Business Paper

Camden Local Planning Panel

21 June 2022

SUBJECT: PONDICHERRY PLANNING PROPOSAL
FROM: Team Leader Land Use Planning
EDMS #: 22/164610

Figure 3: Pondicherry draft Indicative Layout Plan

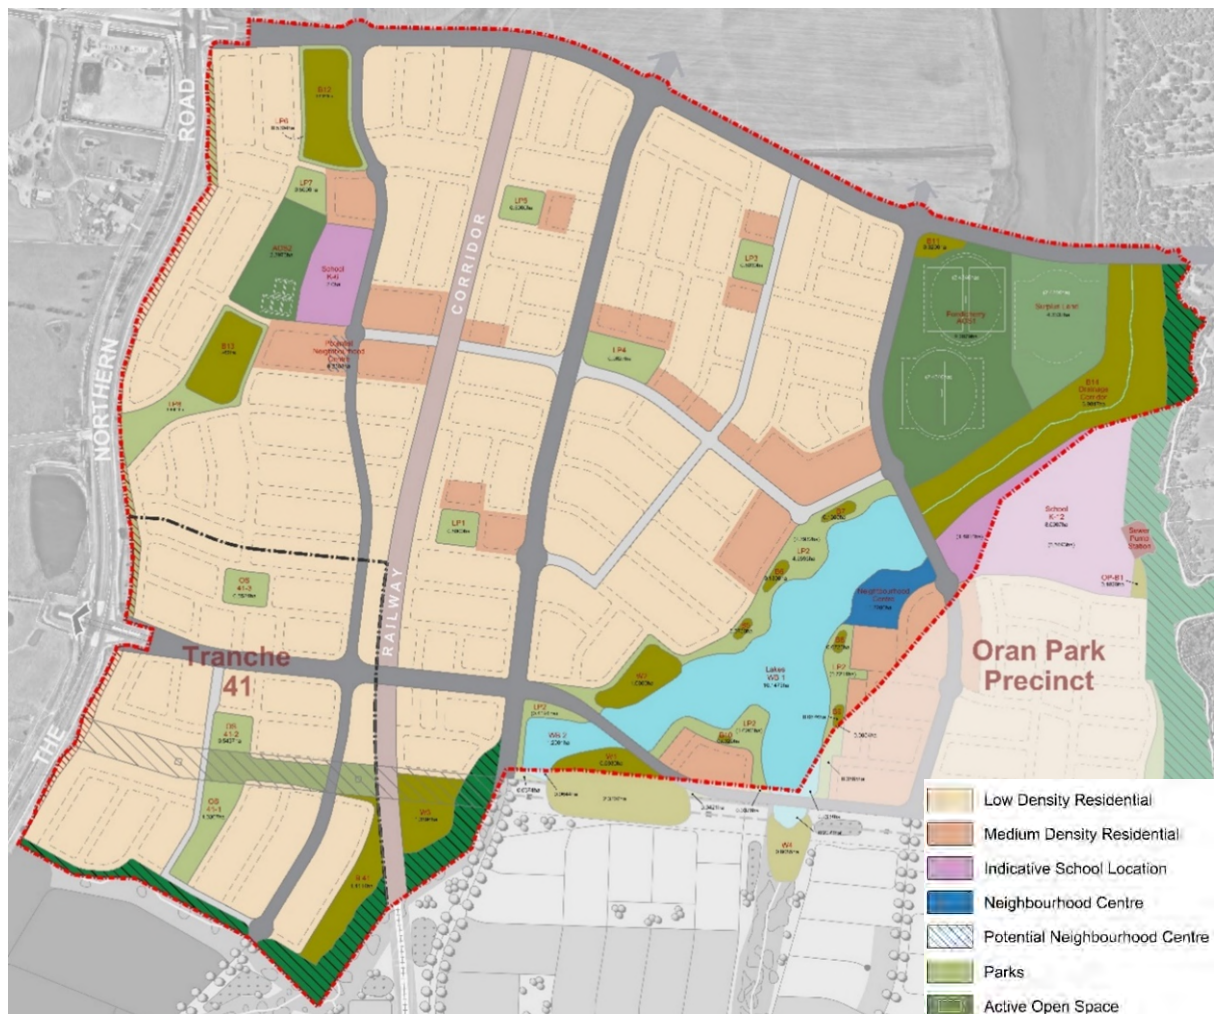
Council officers support the quantum and arrangement of active and passive open space contained in the draft ILP and note the lake water body is not included in the

In terms of community facilities, Council officers provide in-principle support for the proposed relocation of the community centre from Oran Park to eastern Pondicherry adjoining the lake. Subject to the proposal being supported, officers will consider the provision of community facilities in Oran Park to ensure there is no under-allocation because of the proposed relocation. If required, this matter can be addressed as part of the assessment and negotiations on the draft VPA.

Council officers are liaising with the proponent to improve east–west connectivity between the lakeside neighbourhood centre and the South Creek Corridor. The proposed draft DCP provisions for the K-12 school limit access between the lake precinct and South Creek. Should the proposal be supported, improvements post-Gateway should be undertaken to improve the interface of the K-12 school with South Creek and Dransfield Drive.

- Update the proposal report to address the western neighbourhood centre.
- Amend part 3 of the draft DCP to include controls that address the development of the small, western neighbourhood centre.
- Amend the draft ILP to delete reference to 'potential' in relation to the western neighbourhood centre.

Figure 7: Potential Areas of Contamination Risk

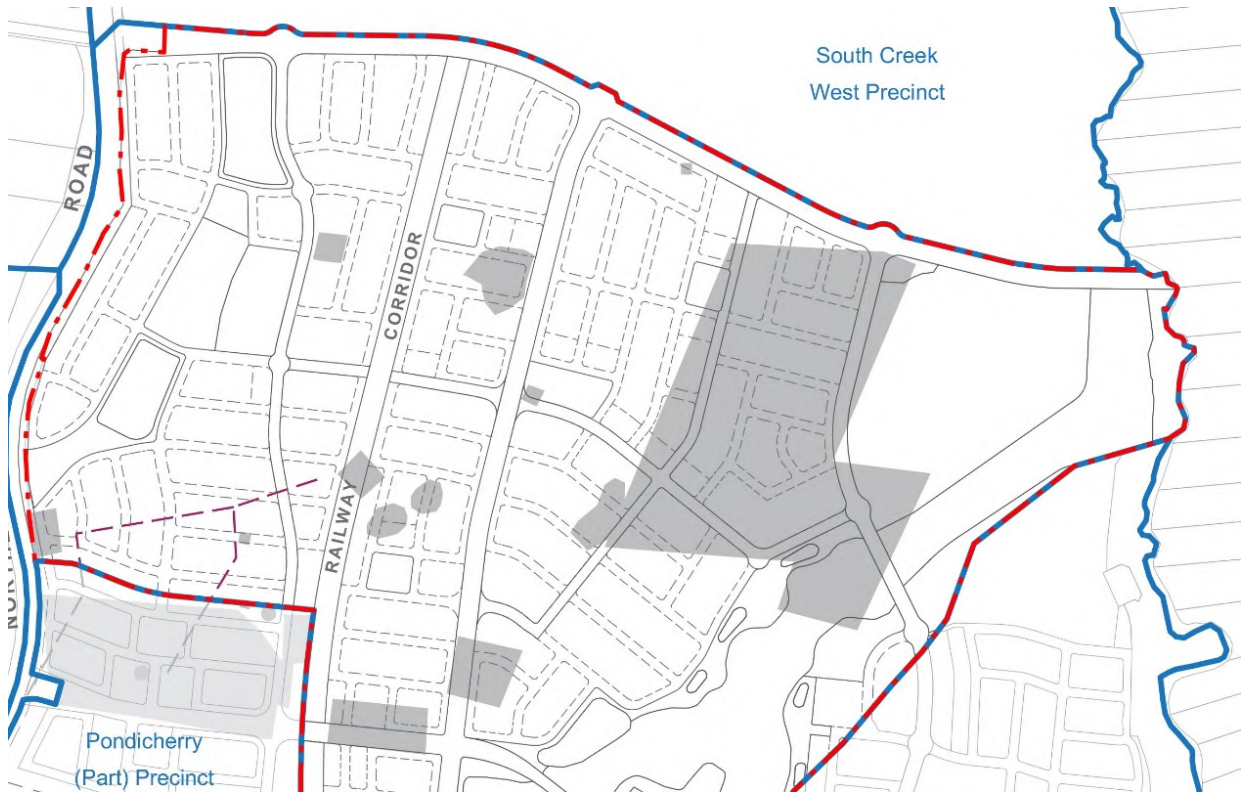
The draft DCP includes a potential contamination risk figure (**Figure 7**) that identifies AECs, and this is supported. A detailed site investigation would be required for subdivision development applications (DAs) in accordance with the requirements of the Growth Centres DCP.

Figure 8: Temporary 1 in 100-year Flood Extents

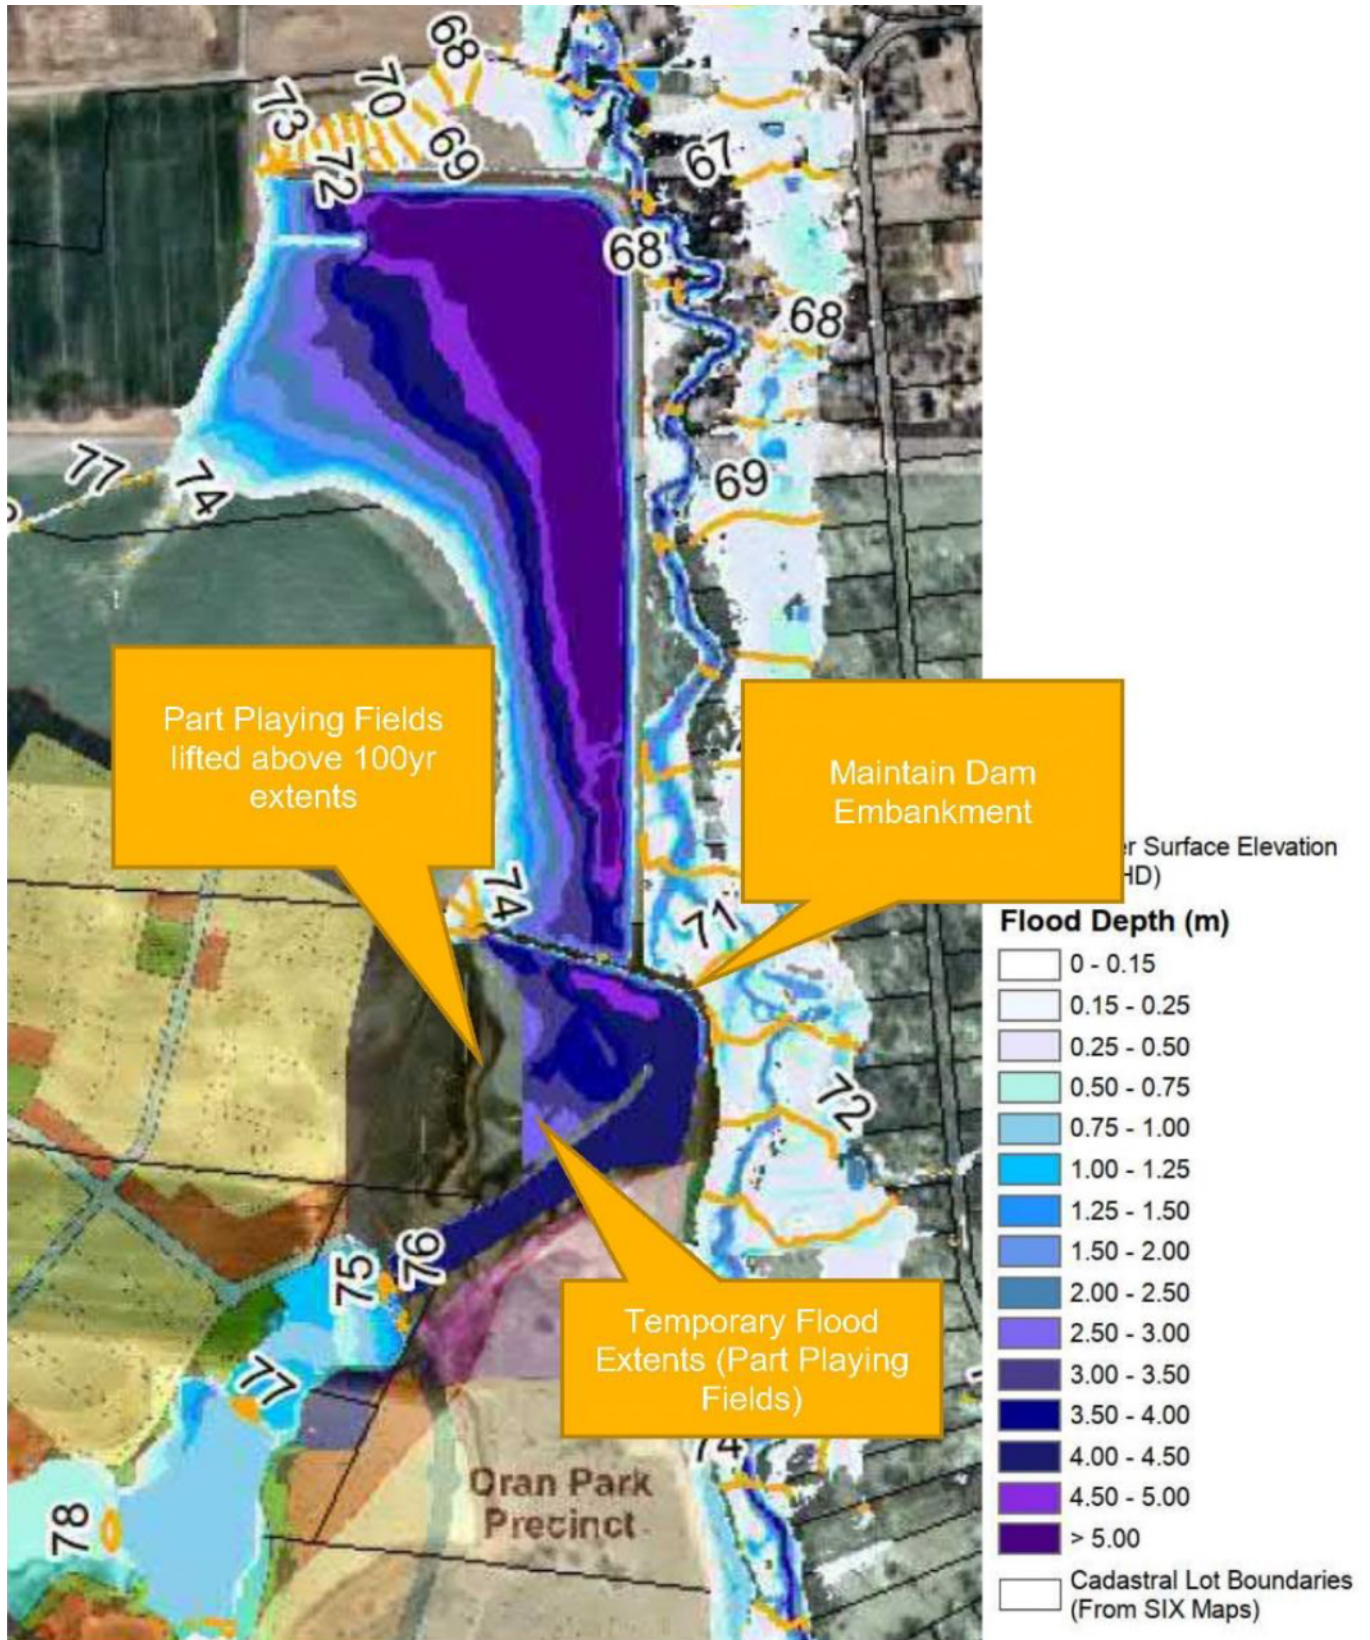
The temporary option for stormwater detention and flood mitigation is supported. Council officers have discussed flood modelling requirements for Pondicherry with the proponent and their flood consultant. Officers have requested the flood modelling for Pondicherry to be revised to be consistent with the Upper South Creek regional flood model framework. It is noted the current Tranche 41 subdivision DAs are required to undertake flood modelling and this work will inform additional, precinct-wide flood modelling, which could be undertaken post-Gateway, subject to the proposal being supported.

It is noted all habitable development (including the K-12 school and neighbourhood centre) are located outside the 1 in 100-year flood extent.

Figure 9: Pondicherry's Watercourses

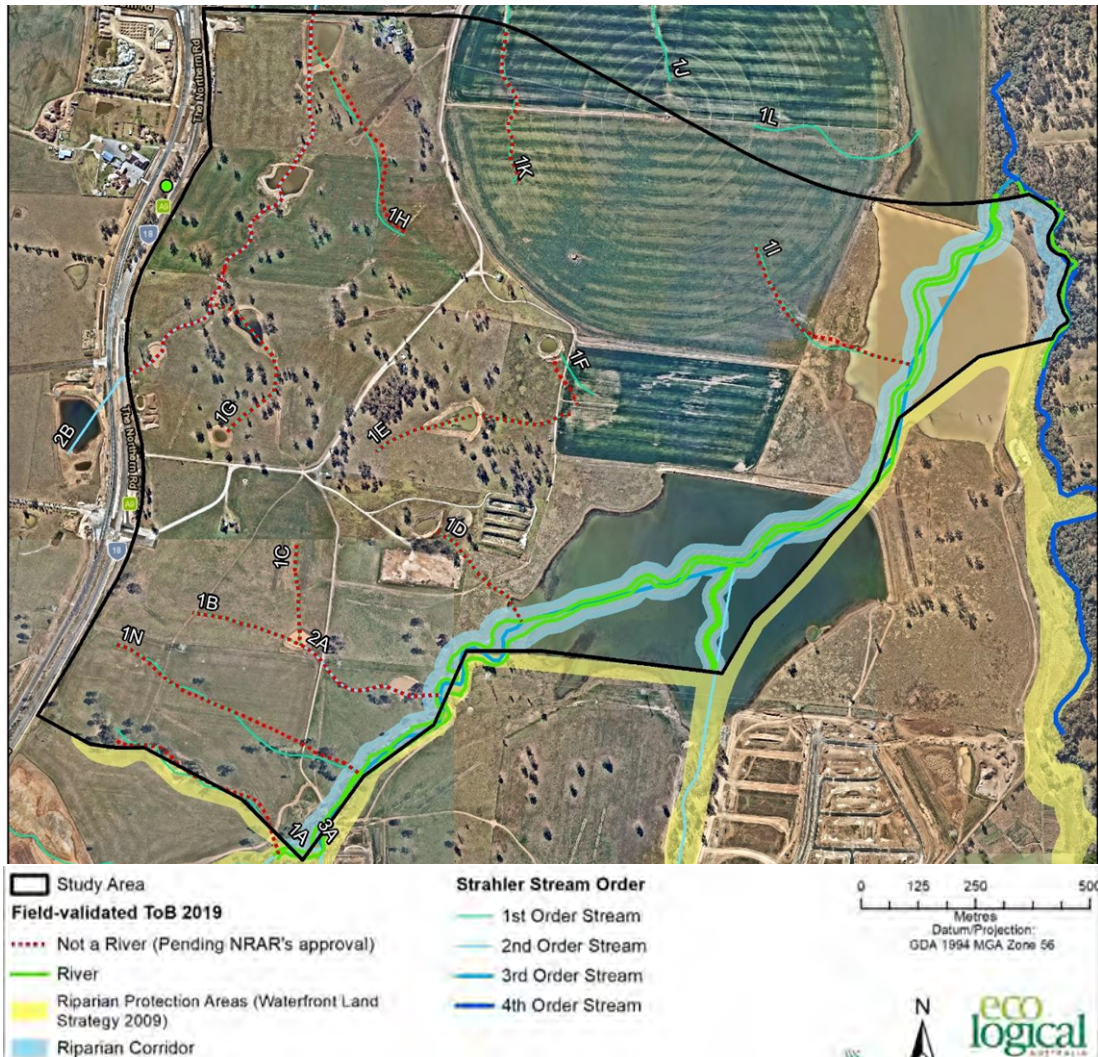
The proposed rehabilitation and embellishment of riparian corridors, including the South Creek corridor is supported and is consistent with the strategic direction to create a blue and green grid in the Camden LGA and Western City.

Figure 10: Odour Impact Area

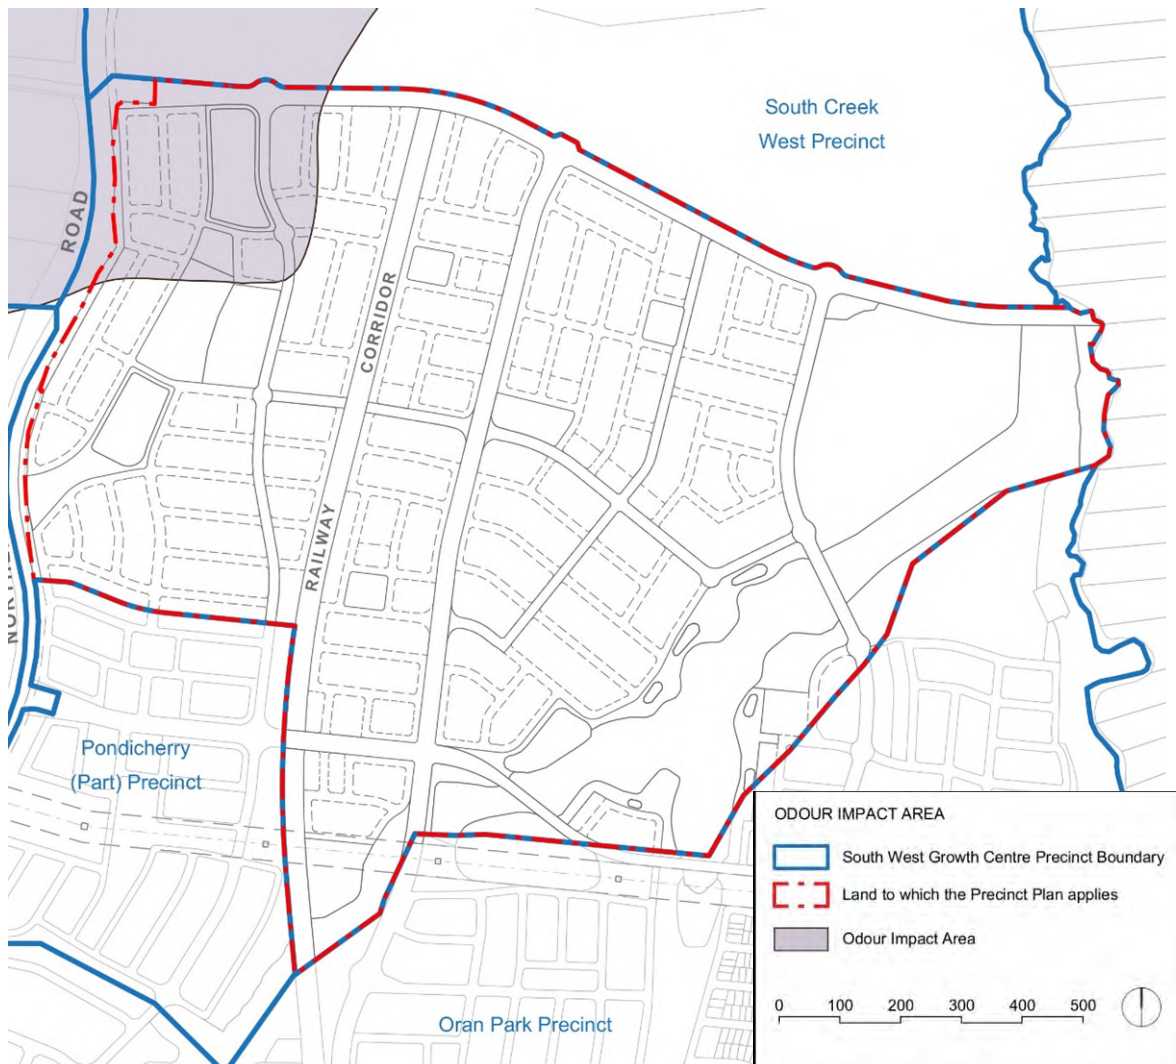
Council's officers have reviewed the Assessment and are satisfied that the potential odour sources would not create odour to a level that would adversely impact on the amenity of future residents and impede the rezoning of Pondicherry. However, further investigations should be undertaken when the northern part of Pondicherry is due to be developed. The draft DCP includes an odour impact area figure (Figure 10Error! Reference source not found.) and this is supported.

Figure 17: Proposed Council VPA Works

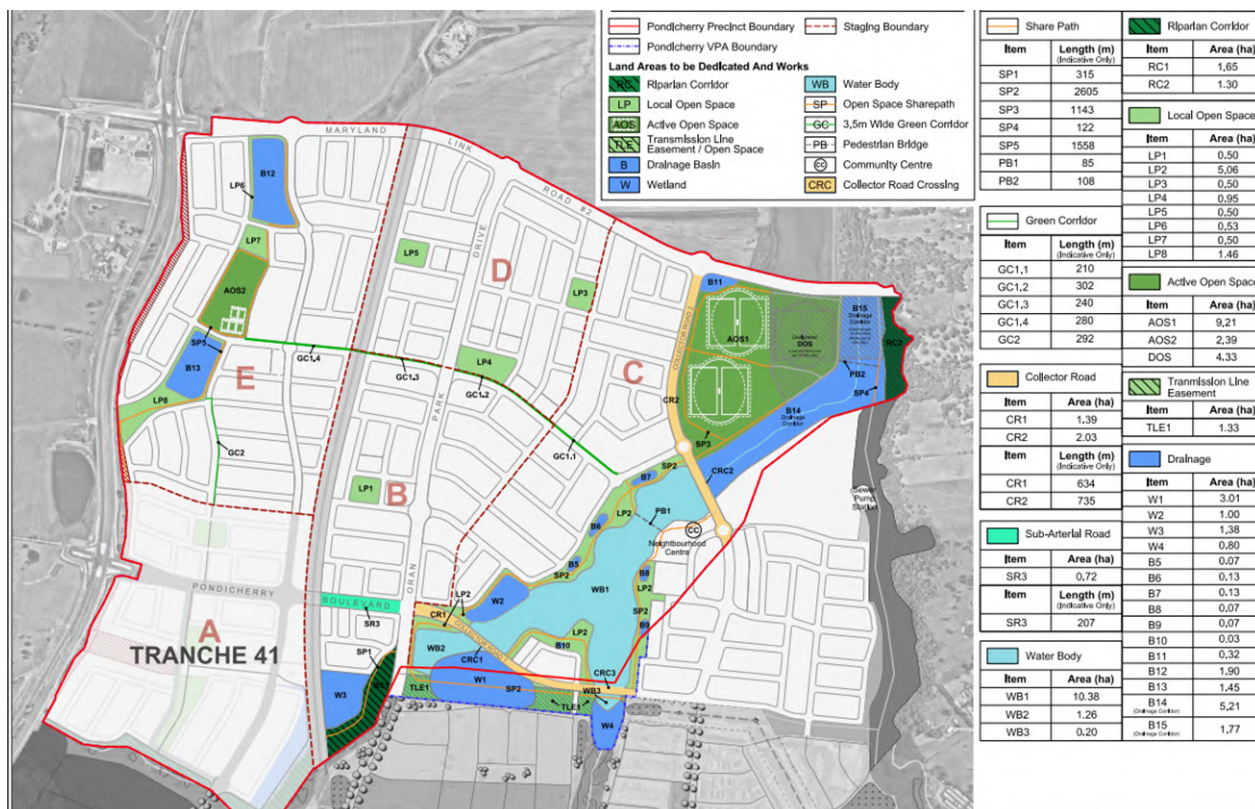
Council officers are currently assessing the revised VPA letter of offer. Should the proposal be supported, negotiations on the draft VPA can progress, along with proposed amendments to the Oran Park VPA to align with the draft Planning Proposal.

Figure 20: Pondicherry Density Bands

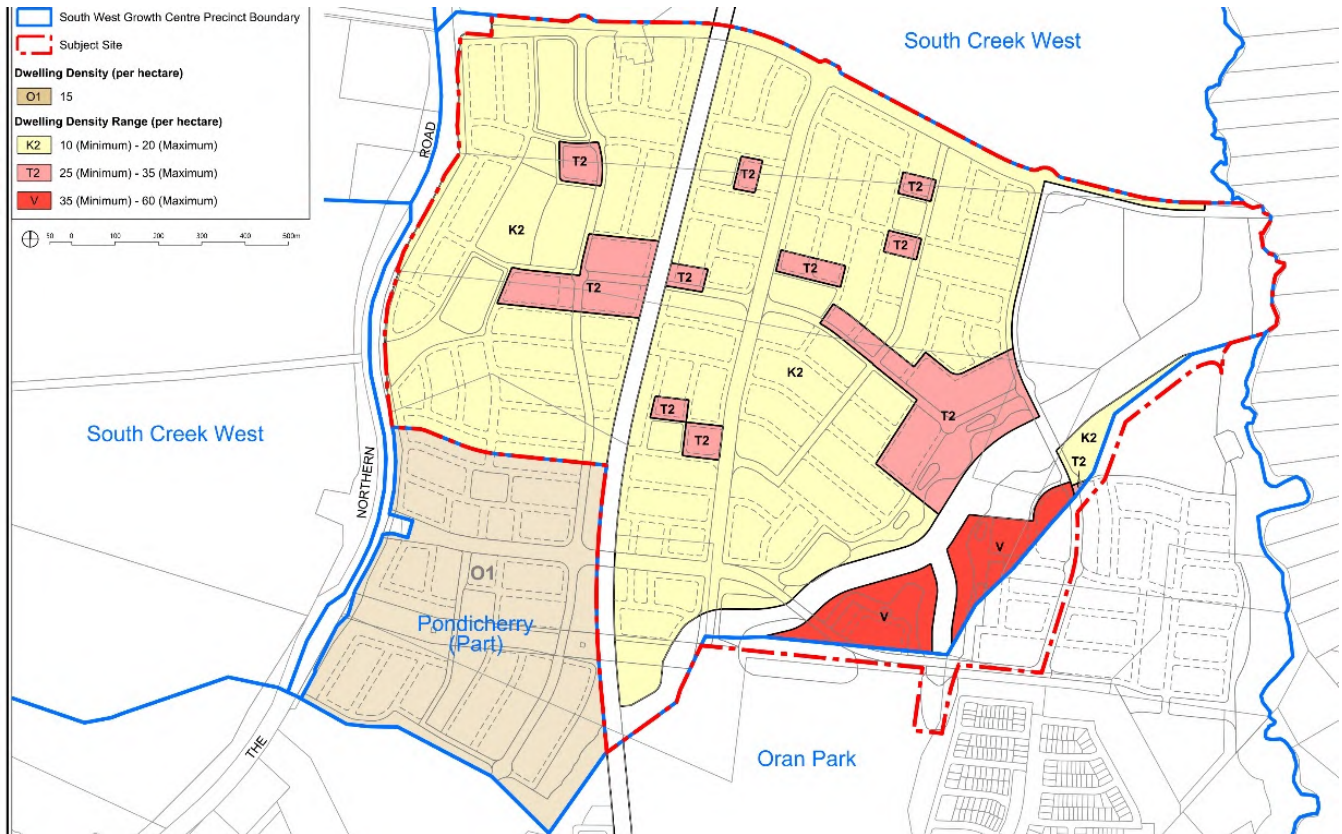
Officers support the application of mapped density bands in the SEPP, consistent with the approach taken in Lowes Creek Maryland and Leppington Precinct stages 2 and 5. This approach aligns with the strategic direction of Council's Local Strategic Planning Statement (LSPS) and Local Housing Strategy (LHS) to increase housing diversity in the Camden LGA by ensuring that housing typologies identified in the ILP are delivered at the DA stage.

The Panel queries the potential range of lot sizes resulting in the residential density band 10 – 20 dwellings per hectare. This would appear to allow lots down to 350 sqm in what is supposed to be the large lot category. A table similar (or simpler) to that contained on page 23 of the planning proposal (see below) would provide greater certainty of a range of lot sizes being delivered. The table appears to indicate approximately 40% will be above 450 sqm.
